- List of errors on the schematic :
- > GPIO9 need to be linked to UserKey
 - > Put the switch only in alim mode and remove the resistor and the LED framed in RED

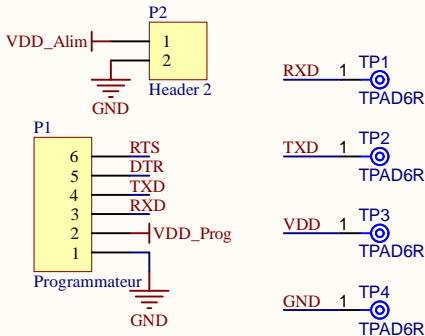
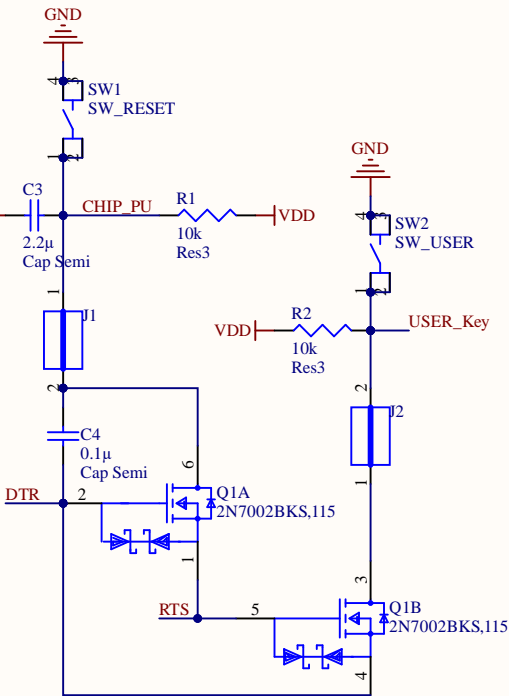
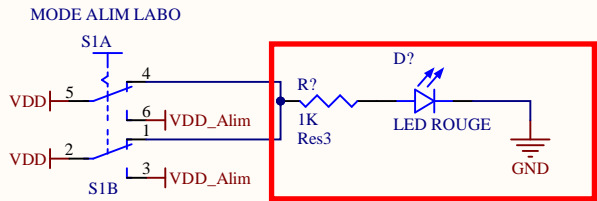
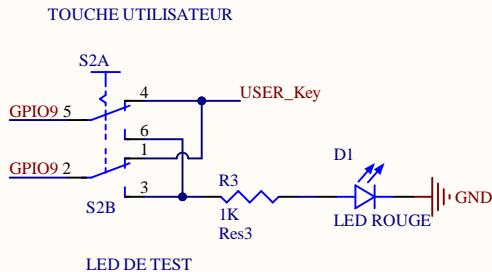
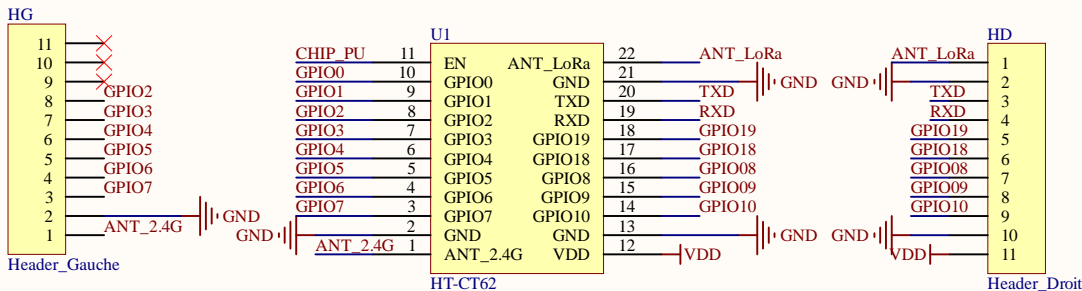
Remove what's in red and only put the switch on alim mode
